Mallee Wind Farm

SSD-53293710

Landscape & Visual Impact Assessment

Addendum

Figure 02 Project Distance to AIS Area
Basemap Source - ESRI, 2025

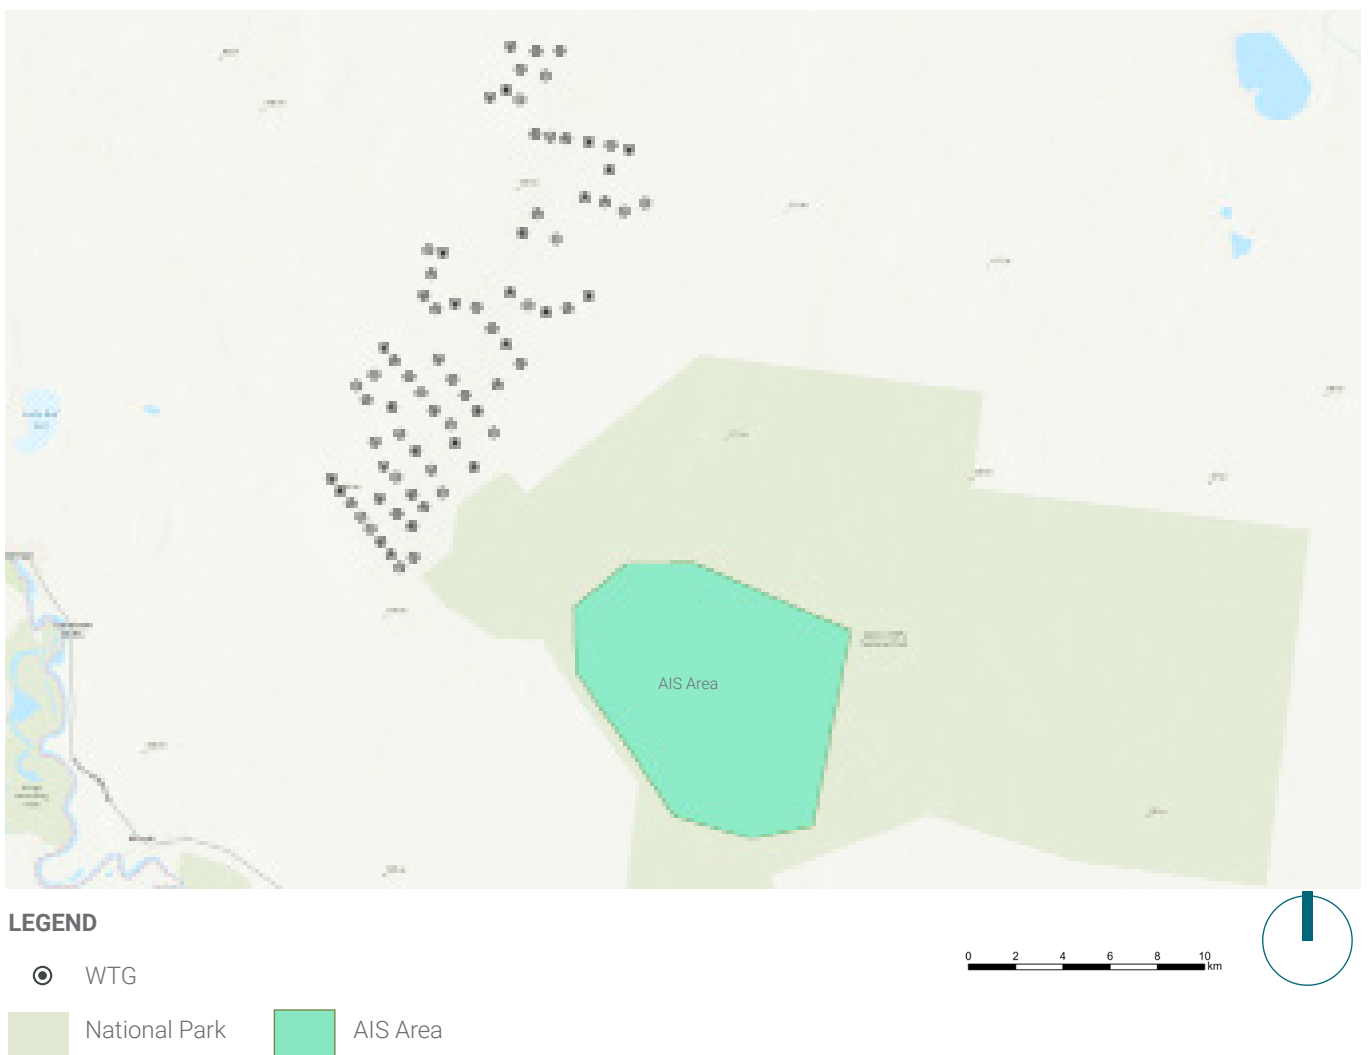
The Willandra Lakes Region World Heritage Area is located approximately 25 km east of the nearest WTG. Light intensity is expected to be indiscernible to the human eye within the AIS area due to distance.
